**Reference:** 3267 NW Skyline Blvd, Portland, Oregon  
UNIT 1 C.O.P. Permit #12-206683-000-00-RS  
UNIT 11 C.O.P. Permit #12-205567-000-00-RS  
UNIT 13 C.O.P. Permit #12-205909-000-00-RS  
UNIT 16 C.O.P. Permit #12-207540-000-00-RS

**LEAD Project No:** 12-188

**Subject:** Plan Review Comments

**EAVE DETAIL**

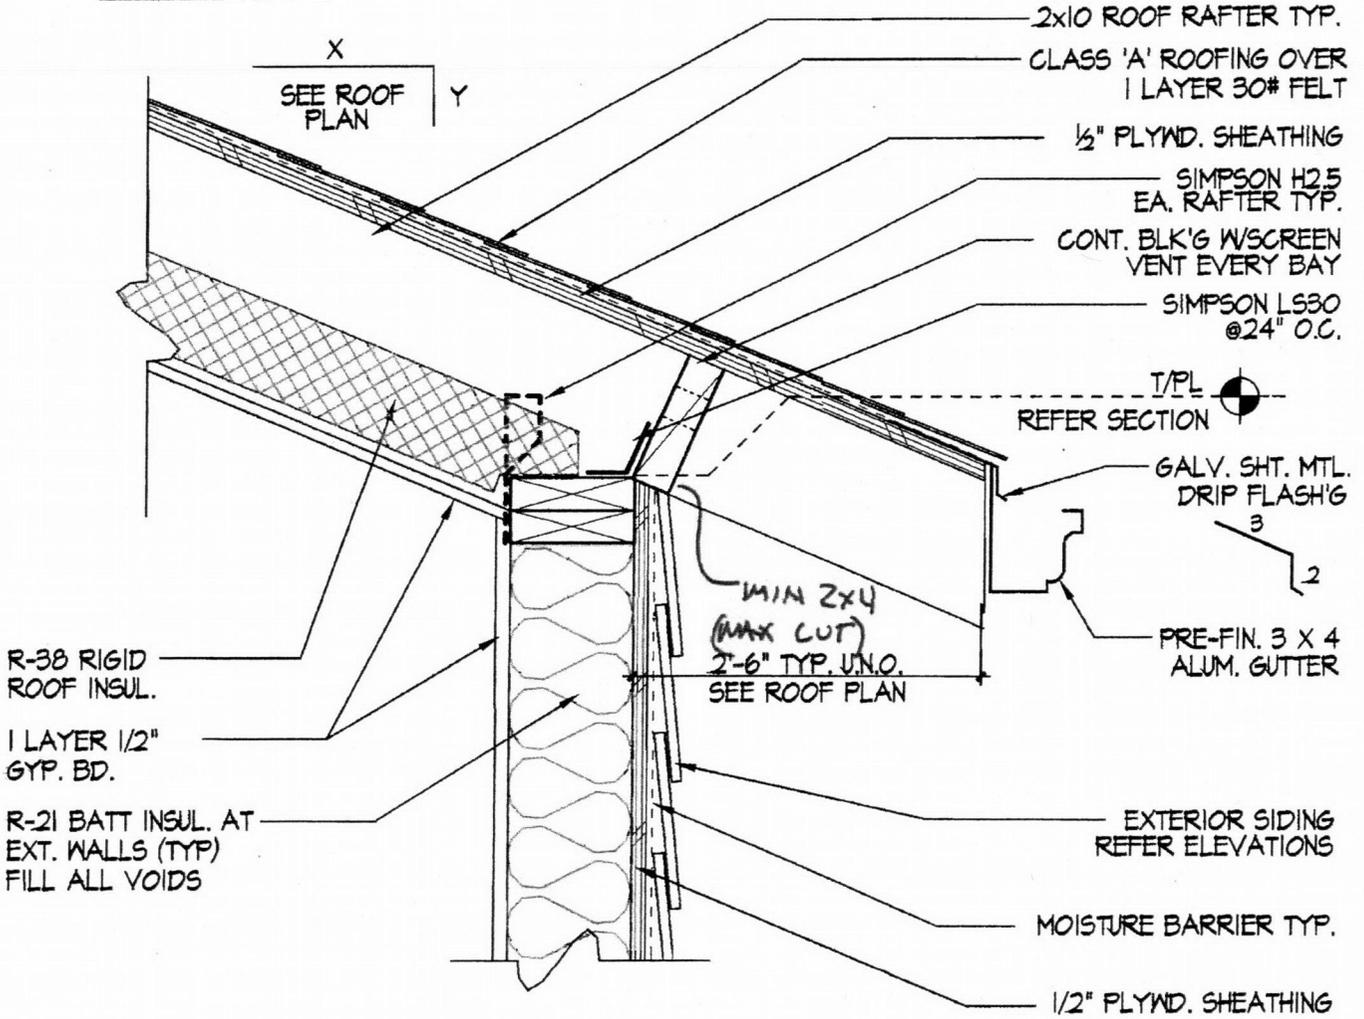
$$\frac{1.5V}{A} = F_v = 1.5 \left( \frac{210 + 360}{1.5(3.5)} \right) = 162.9 \text{ psi}$$

$$162.9 < 180 \text{ psi} \quad \checkmark \text{OK}$$

MIN CUT SIZE  
TO 2x4

SECTION AT BALCONY RAIL  
NTS

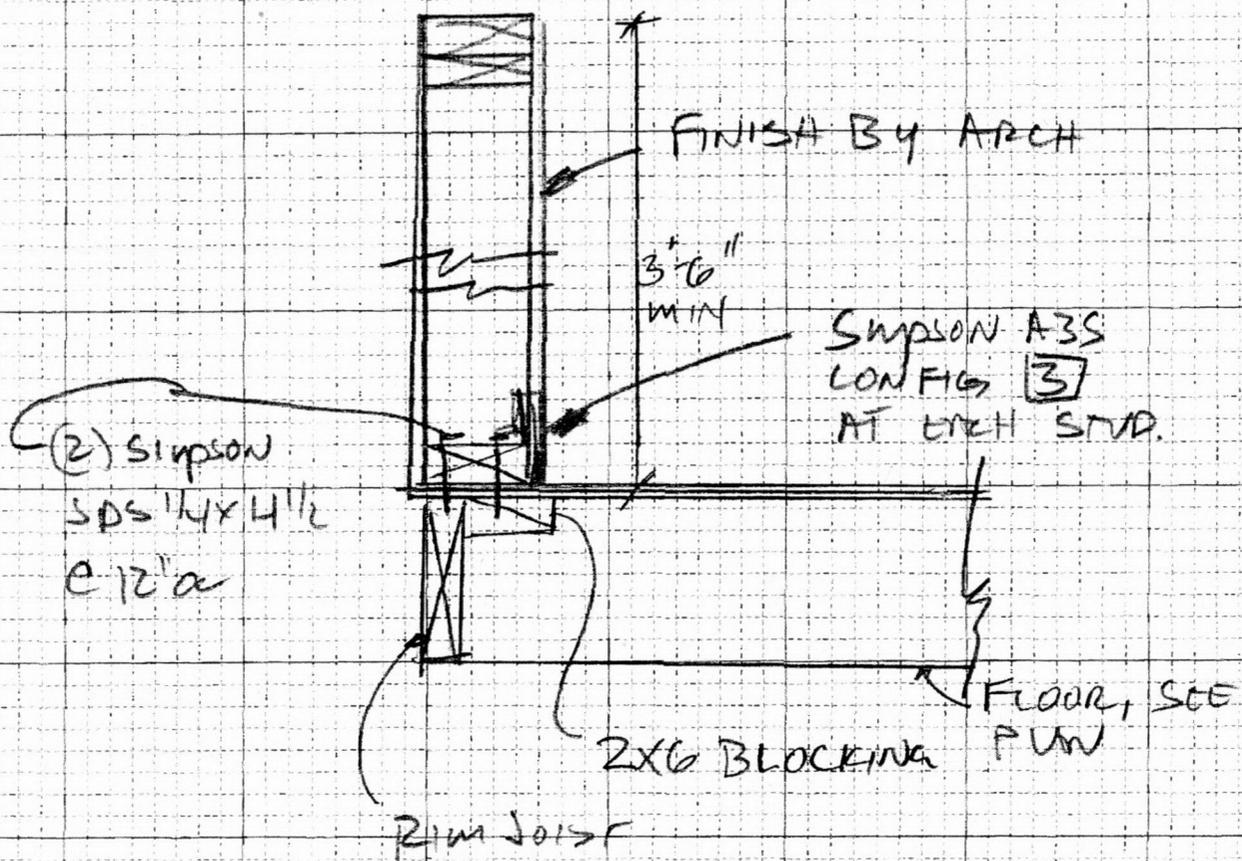
1. Noted. 1 reply has been provided for all for lots.
2. To be addressed by the project architect.
3. Please refer to the detail used for the attachment of the rail at the balcony. Also see the attached structural calculation.
4. To be addressed by the project architect.
5. To be addressed by the project architect.
6. To be addressed by the project architect.
7. To be addressed by the project architect.

BALCONY RAIL CALC

USE (2) 1/4" X 4 1/2 SPS @ 12" OC

CONNECT SPS TO SILL -

USE A35  
CONFIG 3 AT 16" OC

Garage Header

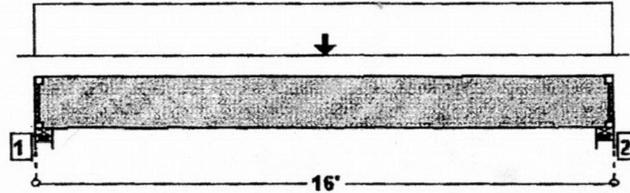
8. There is no need for a stepped foundation detail due to the fact that the site will be excavated to allow a flat footing/foundation at the lowest level.
9. The header beam calculation is provided on page 26 of 33. The beam is called out on plan sheet S4 on the left side of the plan. It is shown on the structural framing plans, therefore the beam should not need to be added to the architectural page, but may be for clarity.
10. Please refer to structural page S1. The shear wall chart and schedule calls for the use of Simpson BP5/8 plate washers which meets the requirement you note. No changes appear to be needed on the submitted plans.
11. To be addressed by the project architect.
12. To be addressed by the project architect.
13. To be addressed by the project architect.
